Your Ref
Y/83/18/HH
Our Ref
PLAN-025521
Date
13/12/2018

Proposal: Change of use of barn to ancillary accomodation. This application affects the setting of a listed building.
Site: 1 Church Farm Cottages, Church Road, Yapton, BN18 0EP.
Y/83/18/HH

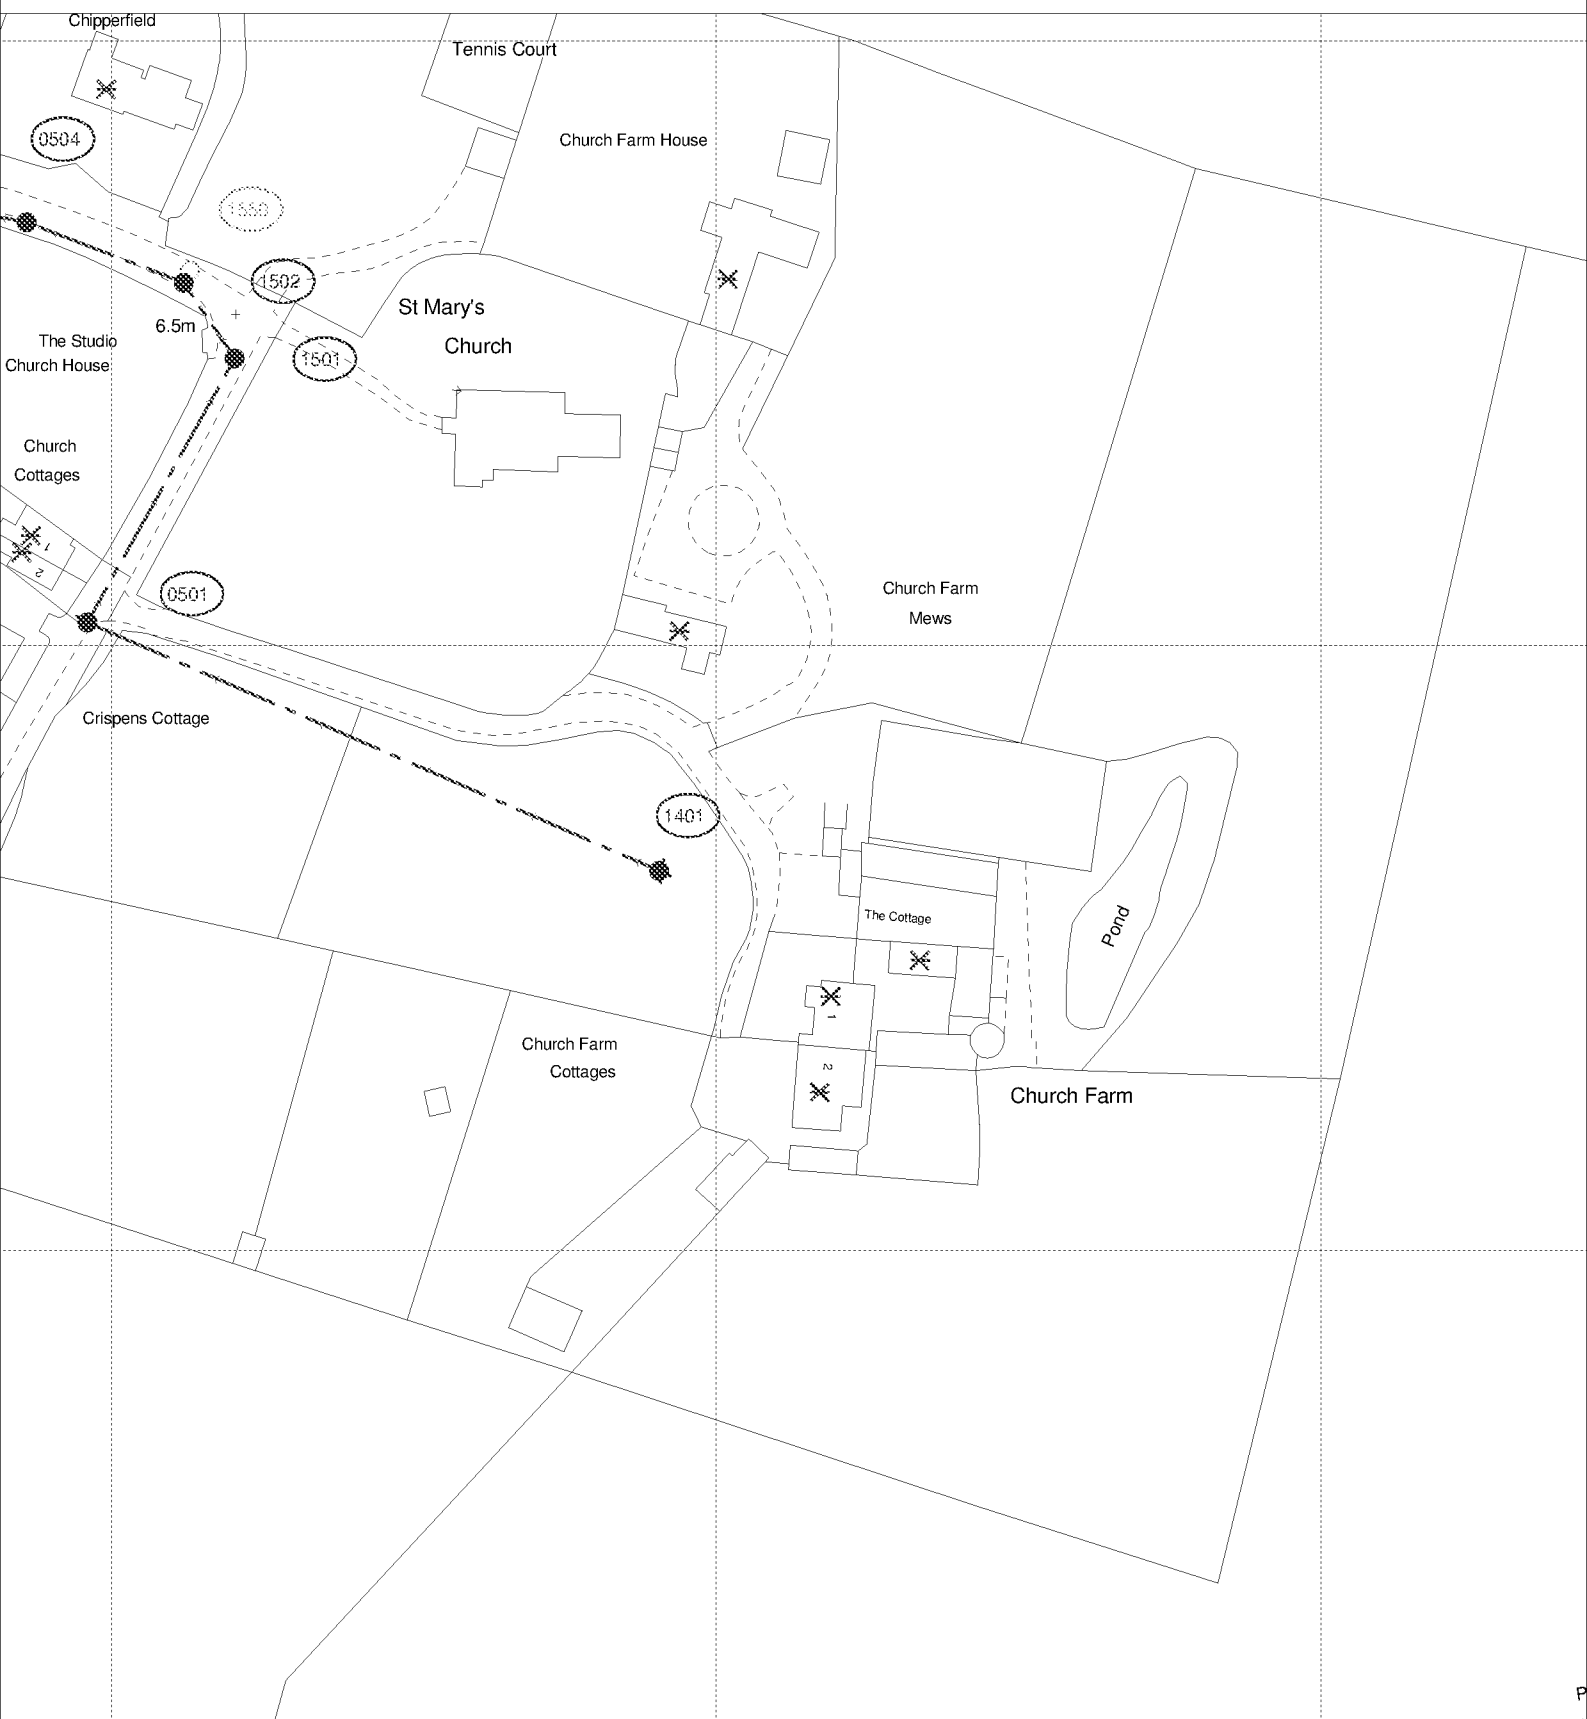
Due to surface water inundation issues in the Lidsey Catchment "The applicant is advised to adopt, where appropriate, the measures in the table "Practical measures to reduce the potential impacts of development".

Developer should look to protect the public sewerage system from inundation and infiltration, which contribute to flooding in unfavourable conditions.
